**USH 41 EXPANSION -
WINNEBAGO COUNTY:
ROAD SAFETY AUDIT**

November 2007

Opus International Consultants was retained by the Wisconsin Department of Transportation (WisDOT) to perform a road safety audit (RSA) of the proposed improvements to USH 41 from STH 26 to Breezewood Lane in Winnebago County. This report discusses the findings of the RSA.

STH 21 & USH 41 SB On-ramp

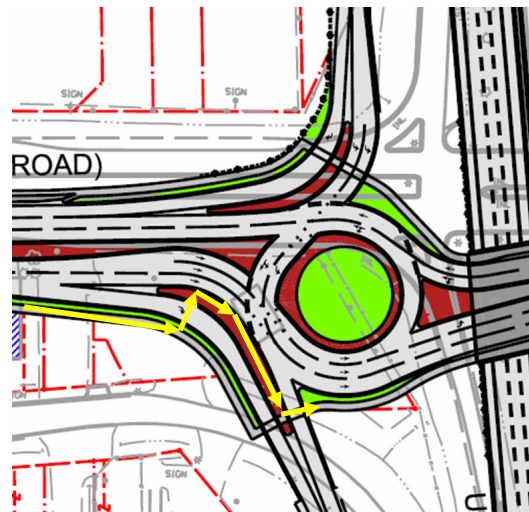
High speed right-turn conflicts with pedestrians and bicyclists

High speed right-turn bypass lanes are planned at several of the planned roundabouts on the corridor. These are primarily being utilized on the on- and off-ramps to maximize the operational performance of the roundabouts.

On several of the bypass lanes which are being planned for freeway on-ramps, crosswalks are proposed to be located near the end of these high speed right-turn lanes. The location of these crosswalks may result in conflicts with pedestrians due to the limited visibility of the crosswalk and the increased speeds.

NCHRP 572² states roundabout exits have a higher percentage of vehicles that do not yield to pedestrians than roundabout entries, suggesting that the design of the exit should be carefully considered to ensure vehicle speeds are reasonable and that good sight lines exist between drivers and pedestrians.

This issue exists at the following locations:

1. *Offset Pedestrian Crossings:* Offsetting the pedestrian crosswalk will improve the visibility of the crosswalk and alert drivers of pedestrians before accelerating speeds on the on-ramp (right). It is suggested that fencing or pedestrian railing be used to formally channelize the pedestrians through the offset crossing.

2. *Introduction of Active Warning Devices:* If the crosswalk cannot be moved, it is suggested that a flashing yellow beacon may be placed on the pedestrian warning sign adjacent to the crosswalk. It is suggested that if a flashing yellow beacon is used in these locations that it should be pushbutton actuated.

SB Koeller & 9th Avenue

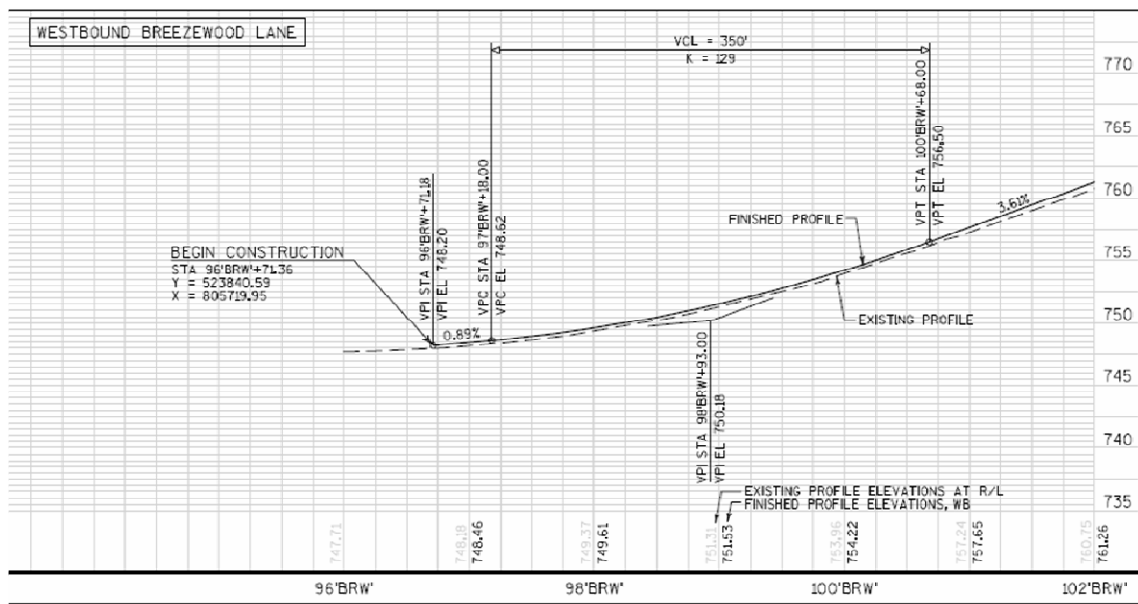
Limited vertical sight distance on roundabout approaches

Several of the roundabouts throughout the corridor are planned for locations where they will be located on the crest of a vertical curve. These locations will provide for limited sight distance on the approaches which may increase the risk of rear-end collisions on the roundabout approaches. While the vertical sight distance to the existing signalized intersections is not necessarily adequate, drivers have the benefit of being able to see the overhead signal mast arms on the approaches

The photo (right) illustrates an example of an intersection with existing sight distance restrictions on the approaches location. The below figure illustrates the proposed vertical curve on the approach to a roundabout at Breezewood Lane.

Safety Issue		Suggestions
1b	1c	
√	√	<i>Flatten the vertical curves:</i> Reducing vertical and horizontal grades will improve sight distance and provide drivers with increased reaction time.
√	√	<i>Lighting on the approaches:</i> Lighting is generally considered beneficial at intersections to improve sight distance and night-time visibility. It is suggested that lighting be provided on all roundabout approaches which include horizontal and vertical curves.

Safety Issue		Suggestions
1b	1c	
	√	<i>Overhead lane use signs:</i> To enhance driver guidance, overhead lane use and/or freeway guide signs may be posted on roundabout approaches to clearly indicate to drivers the required movements for the desired lane. Overhead signing may reduce driver confusion and changing lanes close to the roundabouts, decreasing sideswipe and rear-end collisions.
	√	<i>Extend the splitter islands:</i> This should help to warn drivers that they are approaching a roundabout even though it may not be fully visible due to a horizontal curve.
	√	<i>W1-8 (Chevron) signs:</i> Chevron signs may be posted to provide additional emphasis and guidance to drivers on horizontal curves. Chevron signs may be used as an alternate or supplement to standard delineators on curves.

Limited horizontal sight distance on frontage roads

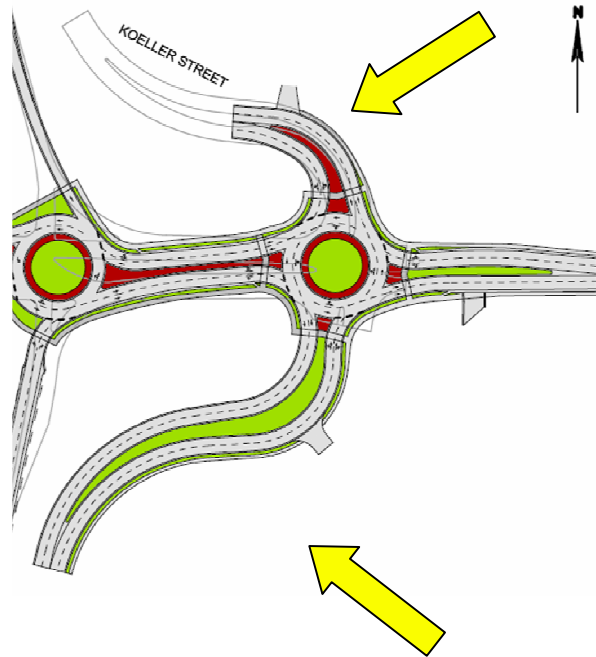
The limited sight distance due to horizontal curves may increase the risk of sideswipe and rear-end collisions approaching a roundabout. A horizontal curve on an approach reduces decision sight distance and approaching drivers' ability to see and react to the roundabout.

Raised Non-Circular Apron:

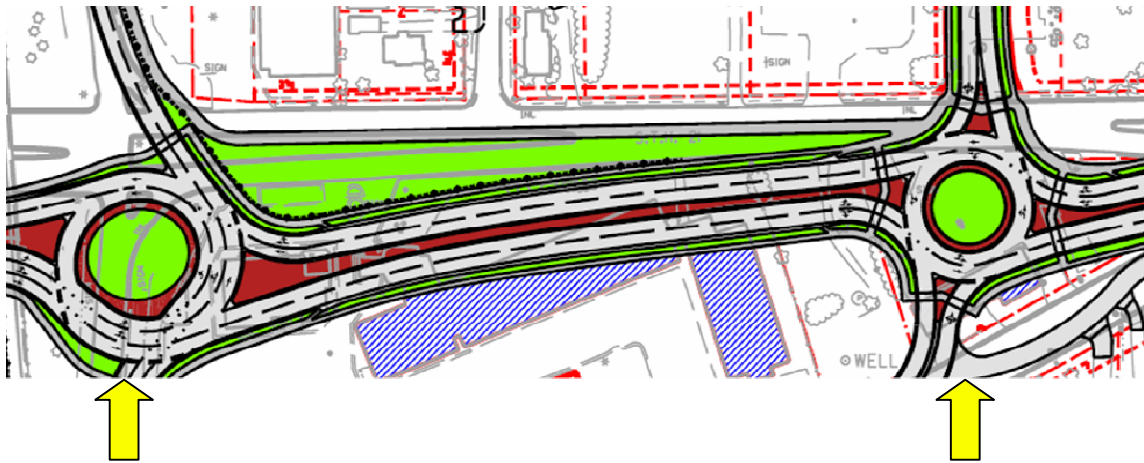
The central islands of several roundabouts utilize a raised non-circular apron. While the non-circular shape is critical when utilizing spiral striping, the raised non-circular shape may cause drivers to hit the curb or drift out of the lane due to the inconsistency with neighboring roundabouts. Additionally, once roundabouts open it is not uncommon for the road agency to have to make minor modifications to the pavement markings. By providing a raised non-circular apron, it will be more difficult and expensive to make minor modifications to the roundabout.

Implement circular aprons: Circular aprons may be used at all roundabouts for consistency. Pavement markings can be used to align or add lanes around the apron (*right*). Pavement markings are a low cost application method to make minor modifications to the apron.

Utility poles close to USH 41 and Frontage Roads

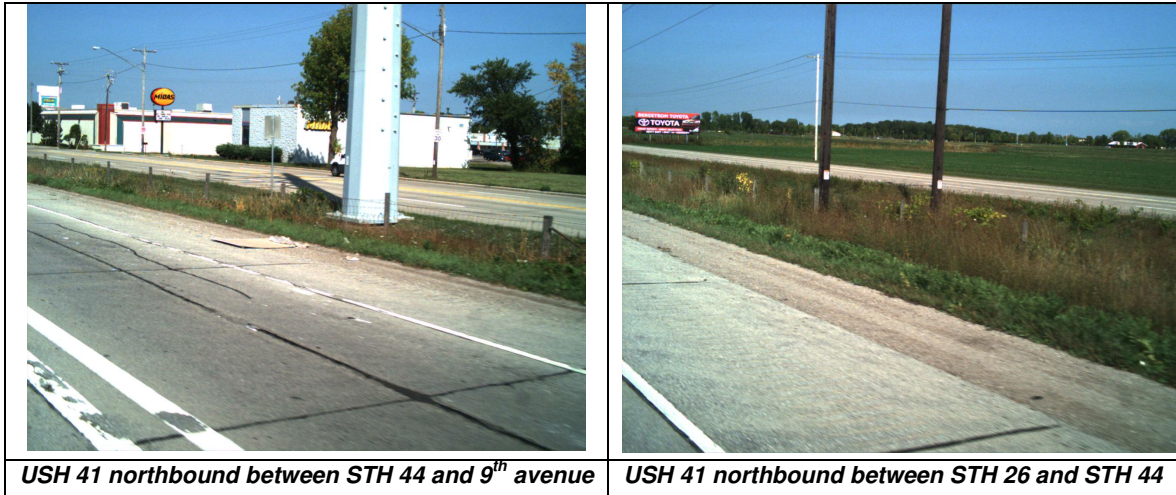
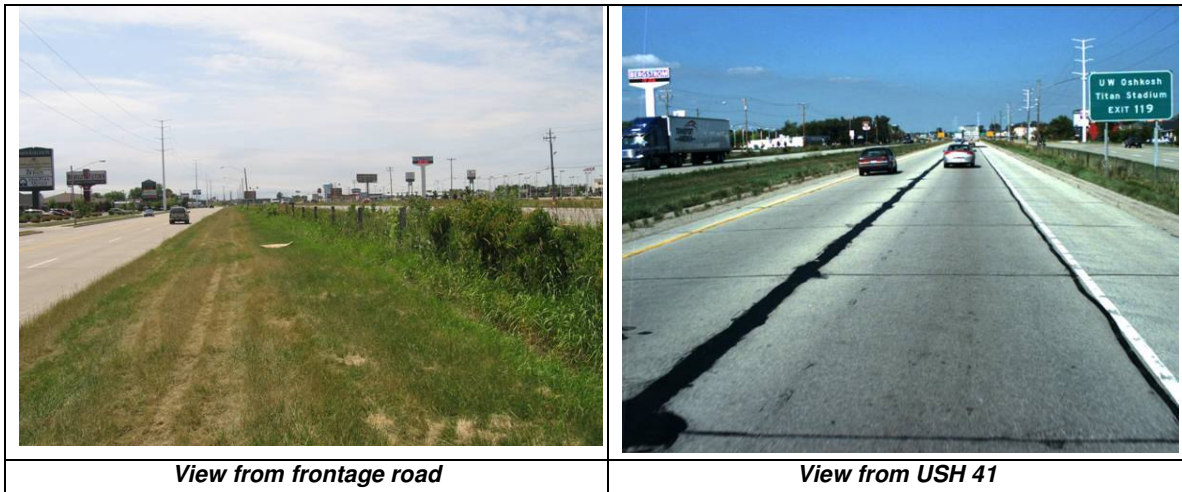
Utility poles adjacent to northbound USH 41 and the east frontage road are located within the clear zone. Due to their proximity to the roadway, drivers are likely to strike one of these fixed objects if they lose control and depart the roadway. The severity of these crashes is increased due to the high speeds which vehicles are traveling on USH 41. If a vehicle traveling at high speeds strikes a utility pole, a severe crash may occur.

1. *Relocate utility poles:* Relocate utility poles out of the clear zone to reduce the possibility of fixed object collisions between vehicles and the utility poles.
2. *Provide barrier protection of fixed objects:* If relocating the utility poles is infeasible, it is suggested that a barrier such as guardrail be provided to shield the fixed object. Guardrail will decrease the severity rating and the possibility of a severe injury due to a fixed object collision.
3. *Provide cable guard rail or barrier:* To prevent vehicles from crossing over the median between USH 41 and the frontage roads, it is suggested that cable guard rail or barrier be considered. Cable guard rail or barrier will help to prevent head-on collisions related to these median crossovers.

Southbound USH 45 off-ramp: Ramp F bridge may block visibility

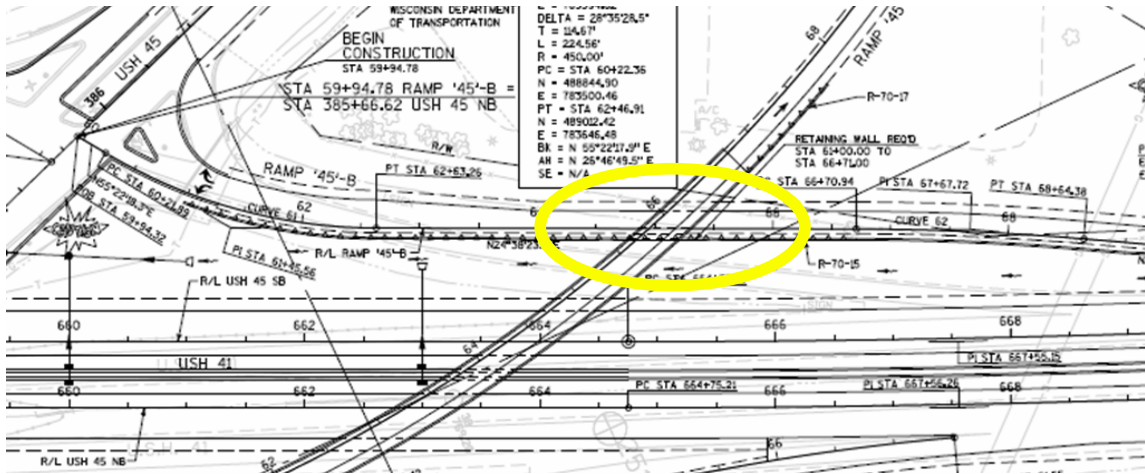
The location of the bridge supports for Ramp F may block driver's sight distance for vehicles traveling on Ramp B. This will reduce decision sight distance and reaction time for drivers approaching the roundabout which is proposed for the intersection of this ramp and USH 45. As a result, this sight distance restriction may result in rear-end collisions.

Relocate the bridge support: It is suggested that relocating the bridge support further away from Ramp B to allow for enhanced sight distance of the roundabout. Enhanced sight distance will result in a additional reaction time and will therefore reduce the possibility of rear-end collisions occurring on this ramp

Proposed Railing between shared-use path and Lake Butte des Morts

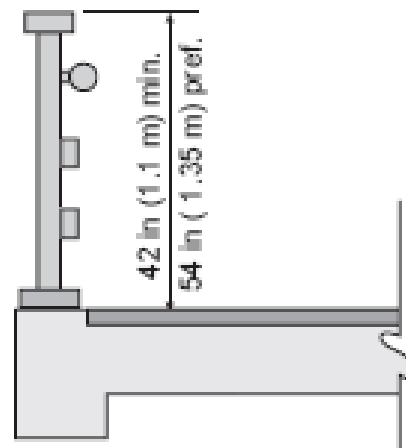
The shared use path along the Lake Butte des Morts Bridge has a barrier between the motorized vehicles and the path. The proposed barrier is 42 inches high. This barrier could pose a risk for bicyclists if they were to fall. Bicyclists are typically seated at least 42 inches off the ground and they could potentially fall over barrier into high speed traffic on USH 41.

No barrier exists between the path and Lake Butte des Morts. In some areas there is a drop greater than 30 feet. This drop may result in pedestrians and bicyclists unintentionally sliding into the lake.

1. *Higher barrier between shared use path and USH 41:* It is suggested that a 54 inch high barrier³ is be used due to the high speeds of traffic along Lake Butte des Morts Bridge. This will reduce the risk that a bicyclist who falls will not fall over the barrier.
2. *Railing along slope:* Due to the drop off of up to 30 feet between the shared use path and the lake, it is suggested that a 54 inch railing⁴ is used (right).
3. *Roadway lighting:* Lighting is generally considered beneficial to provide improved sight distance and night time visibility.
